SERVICE BULLETIN

SERVICE BULLETIN NO. 1

EQUIPMENT TYPE: 30L-1 R-F LINEAR AMPLIFIER

SUBJECT: WIRING CHANGE REQUIRED BEFORE CONVERSION FROM 115 TO 230-VOLT OPERATION IS MADE, USE OF 8-AMPERE LINE FUSES, AND CORRECTION TO INSTRUCTION BOOK DRAWINGS.

Figure 1

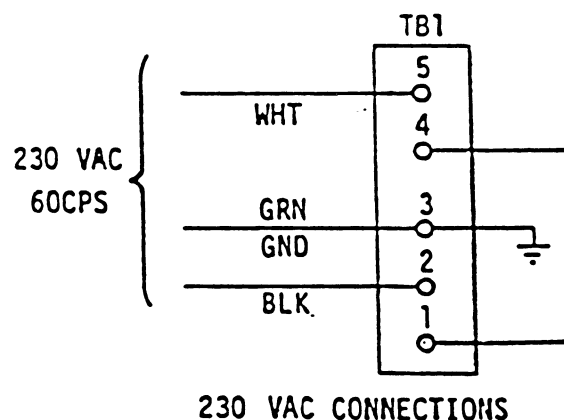
The procedure and schematic for converting operation of the unit from 115 to 230-volts, as detailed in the 5th edition of the 30L-1 R-F Linear Amplifier Instruction Book, dated 15 June 1962, is in error. These errors are corrected in the 6th edition of the above referenced instruction book, dated 15 June 1964. Before conversion is attempted the wiring changes detailed below must be made. After these changes have been made, the conversion can be made by changing the jumper wires on TB1 as shown in figure 1.

Procedure for correcting TB1 wiring to allow conversion from 115 to 230-volt operation:

1. Remove a-c power cord from the primary power source.
2. Lift the cabinet lid and remove the two Phillips-head screws located on the front panel rim.
3. Remove the four feet and the Phillips-head screw that is located between the rear feet.
4. Remove amplifier chassis from cabinet. The easiest way to do this is to place amplifier panel down on a padded surface.
5. Remove the screws from the bottom panel and both end panels of the amplifier. Lift out the bottom shield.
6. Move the white wire from the power cord from terminal 1 to terminal 2 on terminal strip TB1.
7. Move the lead of capacitor C4 from terminal 1 to terminal 2 of TB1.
8. Reassemble unit and return to operation. (Conversion from 115 to 230-volt operation and vice versa now can be made by connecting the jumper units on terminal strip TB1 as shown in figure 1.)

Termination of AC Power Cord at Terminal Strip TB1
